Technical Advisory Note

Quality Information	
Project:	Cumberland Centres Transport Study
Project Number:	SCT_00160
Document Name:	Burnett Street Neighbourhood Centre, Merrylands Proposed Planning Controls – Traffic Advice
Date:	3 August 2023
Prepared:	Shawn Cen, Principal Consultant
Reviewed:	Andy Yung, Director
Authorised:	Andy Yung, Director

Burnett Street Neighbourhood Centre, Merrylands

Figure 1 Burnett Street Neighbourhood Centre planning controls

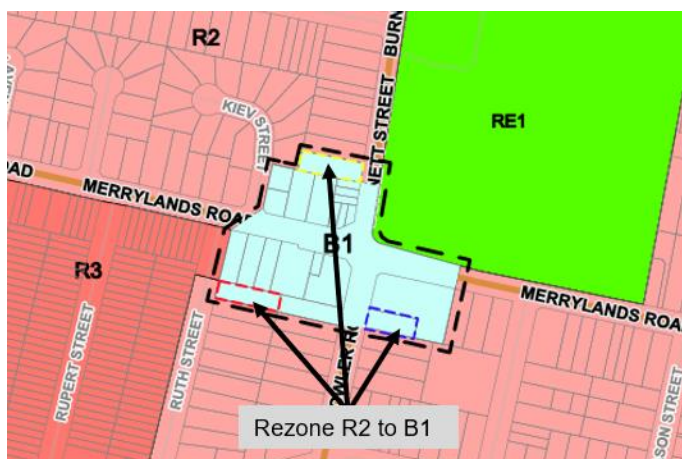
These additional vehicle trips are likely to have a minor impact on the network, although they are unlikely to require a detailed TIA or traffic modelling at the planning proposal stage. However, there may be a need for a brief traffic impact statement to qualitatively review the impacts during the DA stage, particularly at the **Merrylands Road / Burnett Street intersection**.

Additionally, given the number of additional dwellings and the distance to Merrylands station, consideration should be given to the potential for improvements to **bus connectivity** (in particular bus route 806 to Merrylands and Parramatta), and the potential for a **cycle route** to link residents to Merrylands town centre.
